mcHF Hardware modifications as of November 27, 2014
as compiled by KA7OEI for
Version 0.3 UI and Version 0.4 RF boards

The 4.7 ohm resistor added to the UI_8V line feeding U2, the audio amplifier.

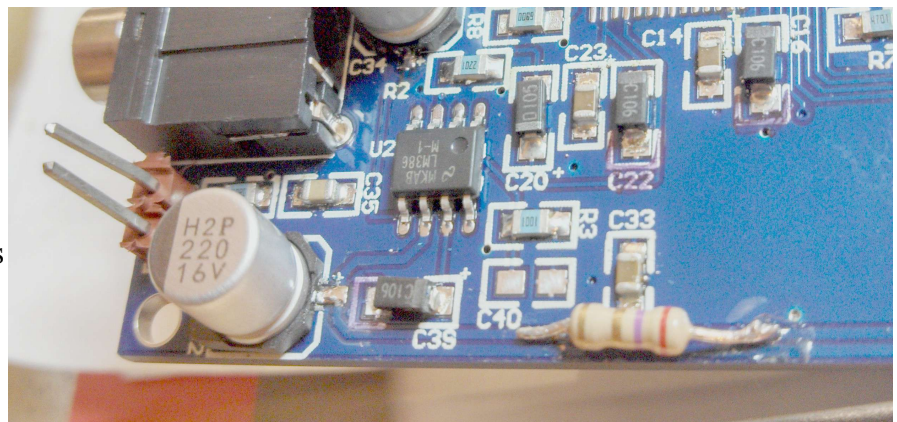
Reduction of conducted audio on the 8 volt line that causes audio feedback:

This modification prevents audio from appearing on the 8 volt line which, in turn, causes audio to appear on the ground busses and other power supplies in the radio which can cause feedback, particularly at high volume levels with wider audio filters.

The insertion of a 4.7 ohm, 1/2 watt resistor in series (or two 10 ohm 1/8 watt resistors in parallel) with the +8 volt line, near the LM386 audio amplifier.

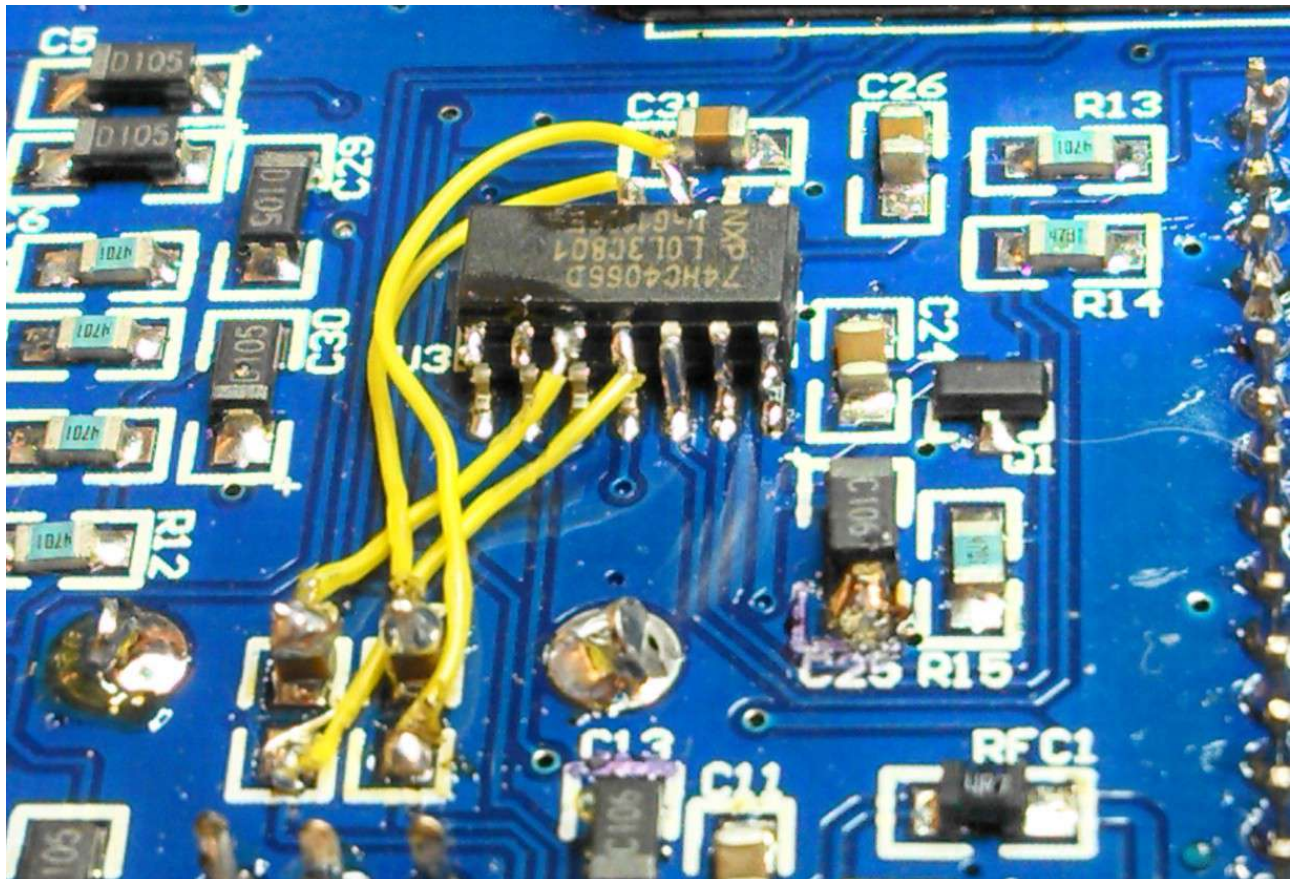
If you have done the other modifications, and you still get feedback when using a speaker, at high volume levels:

It has been noted that even with this modification having been done, if all of the other noise reduction modifications described in this are also done the receiver sensitivity is increased enough that the addition of just the 4.7 ohm resistor may not be enough to prevent feedback at high volume levels. This can sound like a howl, or just a “hollow” sound at high volume levels, with worsened feedback in the 300 Hz setting.

If this describes what is happening to you, this fix is also quite simple: Increase the capacitance at C32. It has been found that adding another 1000 uF of capacitance across C32 seems to prevent audio feedback, having done all of the other modifications.

The "U3a" modification, piggybacking another 74HC4066 atop U3 to prevent feedback into the receiver.

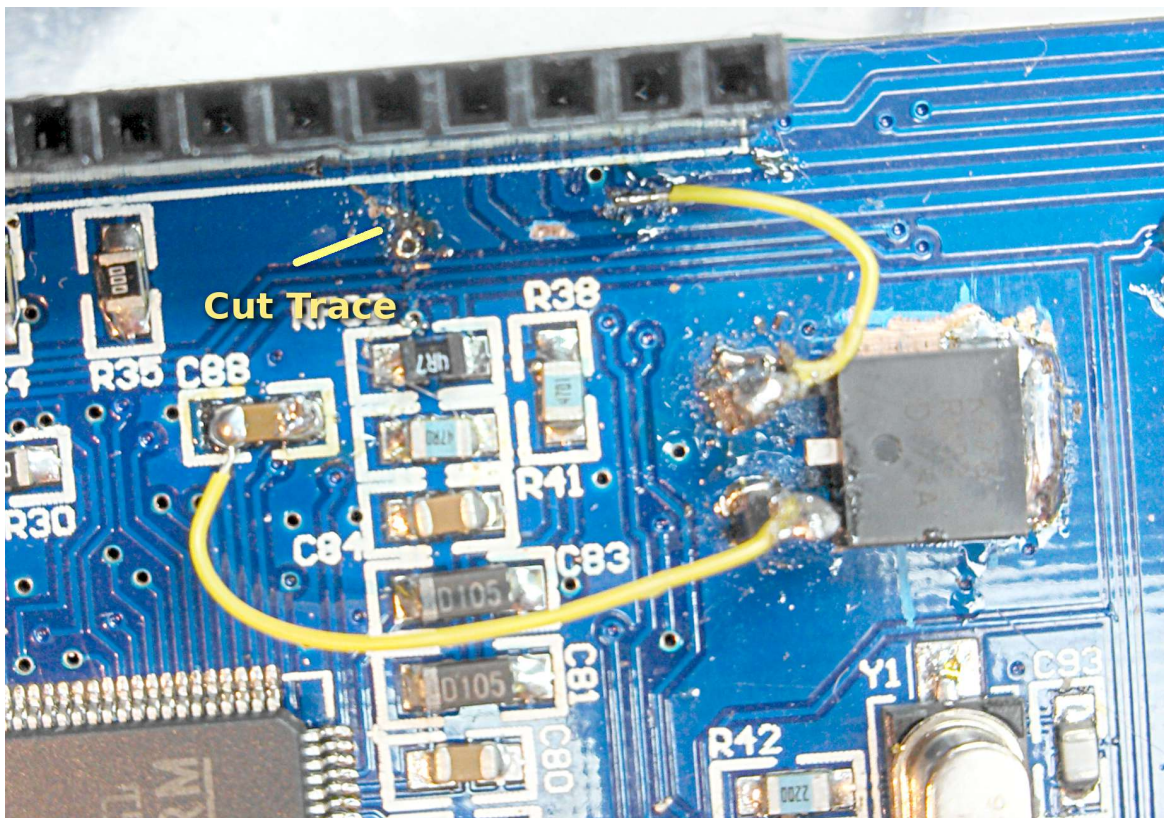
Prevention of RX audio “breakthrough” on the TX mixer:

This fixes a source of distortion/oscillation in the receiver, particularly at high volume levels and on high bands: **This is a very important modification that all users of this transceiver should perform.**

Take a 74HC4066 chip, of the same type and package as U3 and piggyback it atop U3 (on the UI board) and use its power supply and control signals. This chip will now be able to turn on/off the TX I and Q signals with a bit of fairly simple rewiring. Let us call this new chip "U3a"

Diagram of the filter/regulators of the LCD and MCU power supplies. A low-dropout 3.3 volt regulator is used.

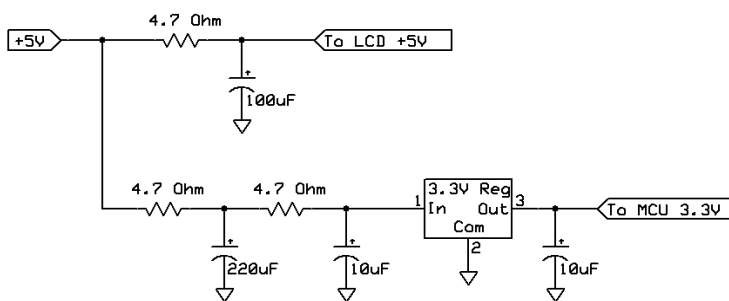
It was noted that when the above modification was completed that there was residual noise on the 5 volt line so further investigation was carried out. It turned out that the remainder of the noise was from two sources:

While the regulator's contribution directly to the 3.3 volt line was significant and moving it to the 5 volt line made a significant improvement, it still put noise on the 5 volt bus which powers devices many other low-level circuits, such as the QSD mixers and, to a lesser degree, the RF signal sources (e.g. local oscillators.)

The 220uF capacitor on the input side of the 3.3 volt regulator, along with the 4.7 ohm resistors, form a low-pass filter that provides an impedance path between the noise source at the input of the regulator and the capacitor, greatly improving its ability to filter. The other 4.7 ohm resistor provides isolation between the noise that remains at the 220 uF capacitor and the rest of the 5 volt bus in the transceiver.

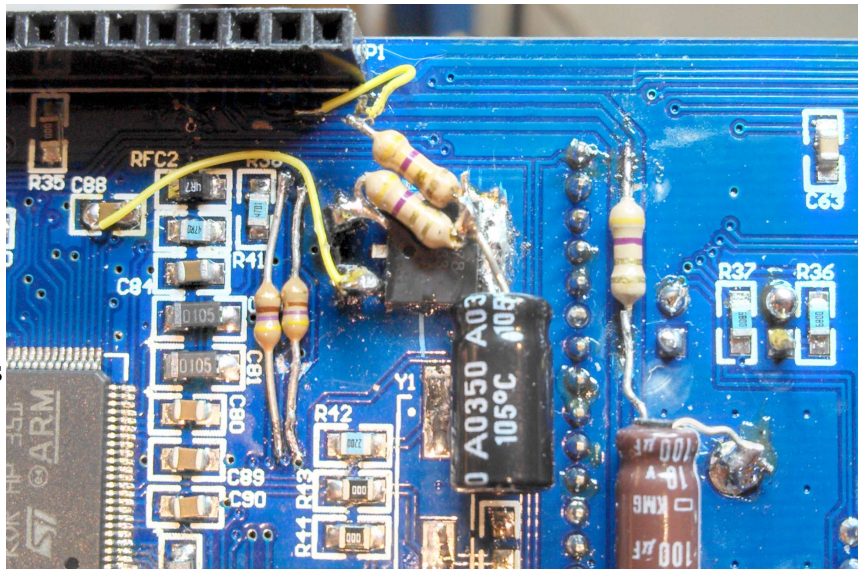
A separate 3.3 volt regulator for the MCU and additional LCD +5V filtering:

With the increase in sensitivity due to the reduced receiver background noise there may be the additional tendency for audio feedback to occur at high volume levels, particularly with no antenna connected *when using a speaker*. This is related to circulating currents on the UI board, some of which were addressed with the addition of the 4.7 ohm resistor in series with the 8 volt line on U2 noted earlier in this document.

The recommended installation of another 3.3 volt regulator on the UI board for the MCU: This mod is actually easier than the "U3a" mod and uses the same type of parts as those that you'd already have gotten (e.g. another 3.3 volt regulator and two more 10uF capacitors.) This reduces one source of low-level noise – much of it in the form of a 1.5 kHz “whine” – getting into the receiver due to the MCU's modulation of current on the 3.3 volt line shared with low-level audio circuitry. Taken together, these two modifications can improve the receiver sensitivity by 2-3 S-units, depending on band.

The trace to isolate the 3.3 volt supply feeding the MCU is indicated on the picture and it should be cut **just above the via** that goes through to the other side of the board. The 3.3 volt output from the added regulator is shown connected to the left-hand side of C88, below.

This picture shows the location of the traces and where the cuts should be made. This is found to the right and above U4a, the MCU. A picture of a “bare” board is used for clarity.

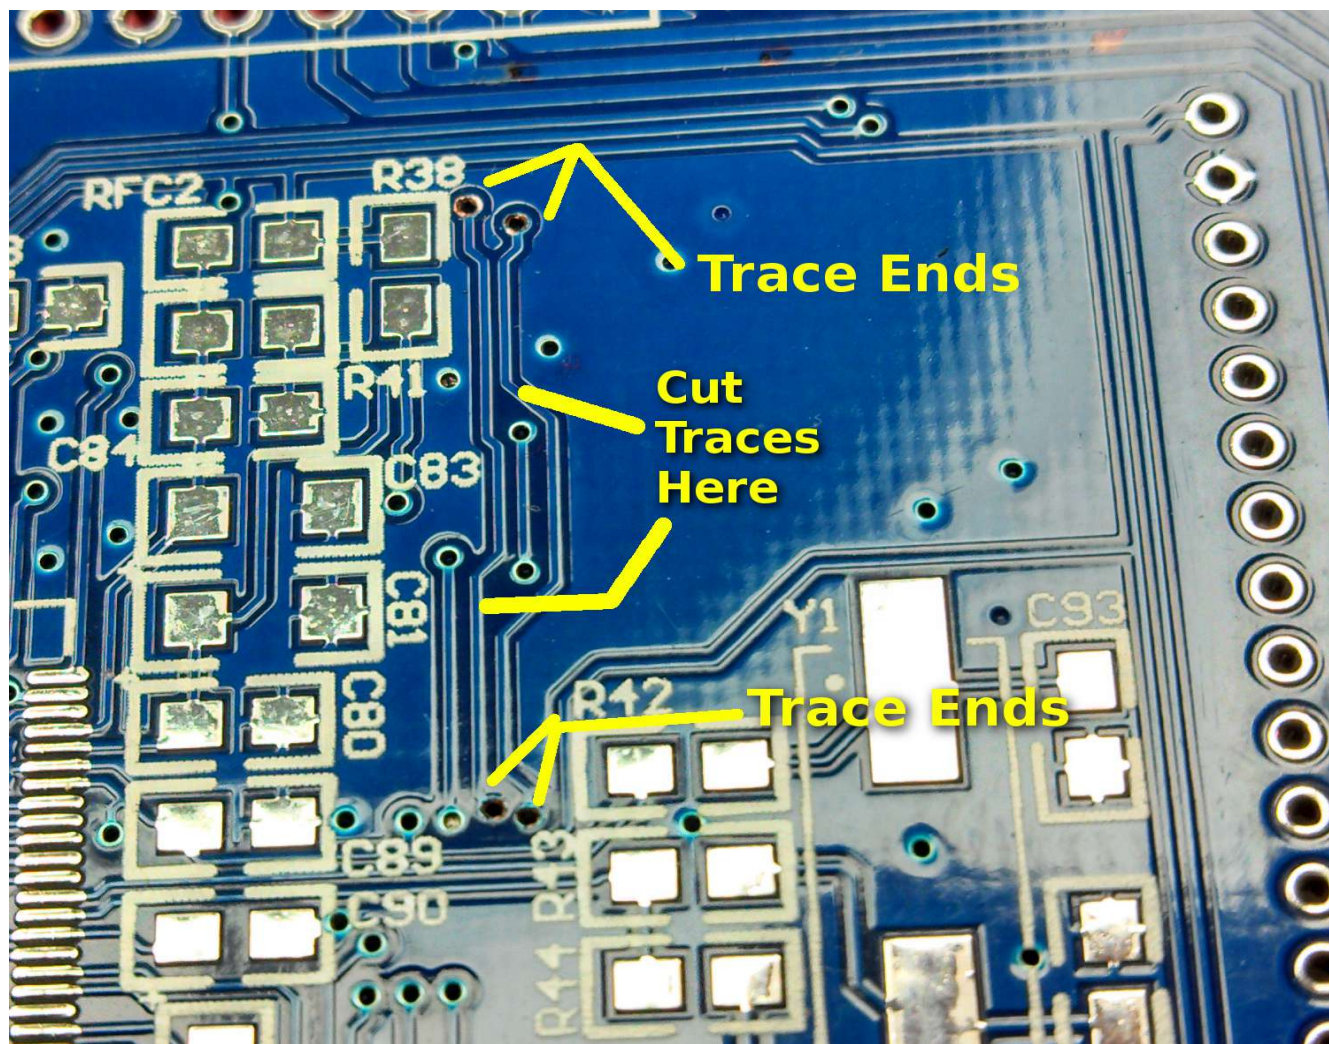
If the above modifications are made, with no antenna connected – or even with an antenna connected when listening on higher bands (especially 20 meters and above) a fairly strong “tick” may be heard every second. This is due to the polling of the onboard temperature sensor and the fact that the “fall” time of the on the I2C line from the MCU is extremely fast and rich with harmonic energy. This problem can be easily “fixed” with the addition of resistors on the UI board in series with the SCL and SDA lines which effectively reduce the slew rate of these lines, quashing the RF energy.

A reasonable value of resistor to install is 470 ohms and the installed components may be seen in the picture.

The added 470 ohm resistors in series with the SCL and SDA lines. Note that this picture also shows the added 3.3 volt MCU regulator mentioned above. 1/8 watt, leaded resistors are used, but surface mount resistors could be used, if desired.

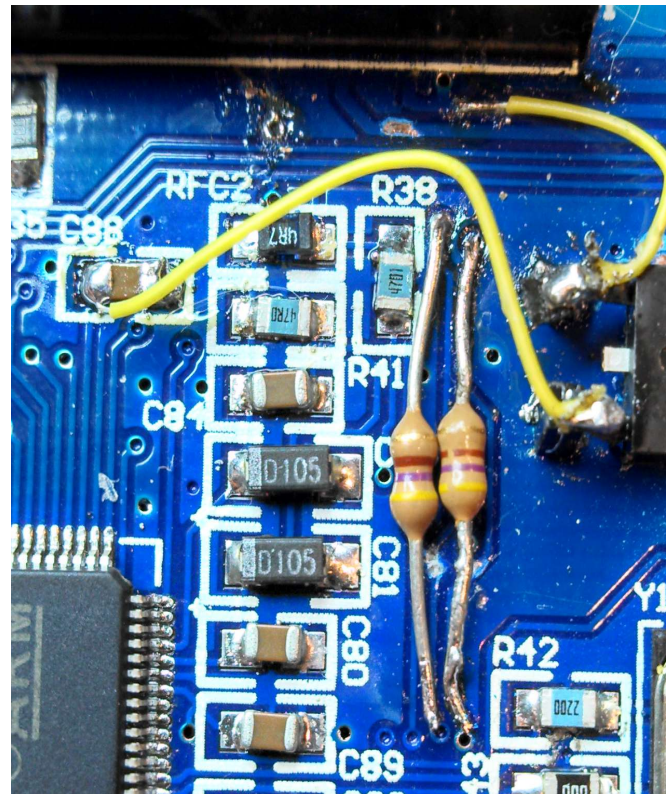
Elimination of the 1-second “tick” noise in the receiver – particularly on the higher bands:

In the picture can be seen the two added 470 ohm resistors. As you can see, I used leaded 1/8 watt resistors, but surface mount resistors can be used, instead if that is your preference. (The 3.3 volt regulator used for the MCU – see the modification earlier in this document – can be partially seen.)

*Of the rise and fall times on the I2C, the slowest slew rate was the **rise** time shown in this digital oscilloscope capture, which is well within the acceptable time for the clocking rate!*

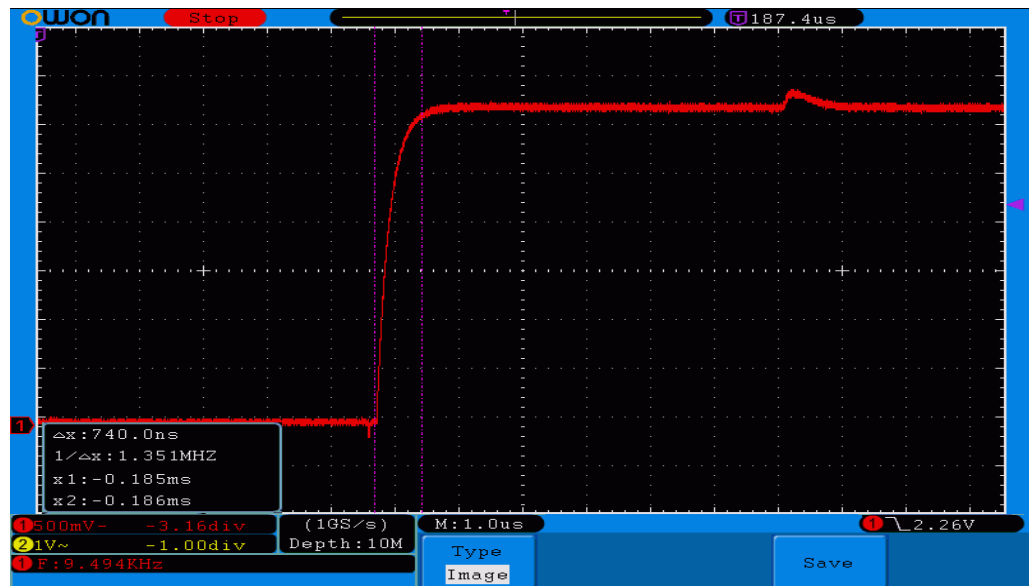
To verify the integrity of the I2C data stream – which is shared with the Si570 frequency synthesizer – I monitored the data stream with a digital storage oscilloscope and measured the worst-case slew rate – which was actually the risetime - the result being noted below.

As can be seen, the risetime is less than 740 ns at the 10%-90% points which is a fraction of the I2C clocking rate, well within the time at which the edge of the clock into which the data is strobed in by the peripheral.
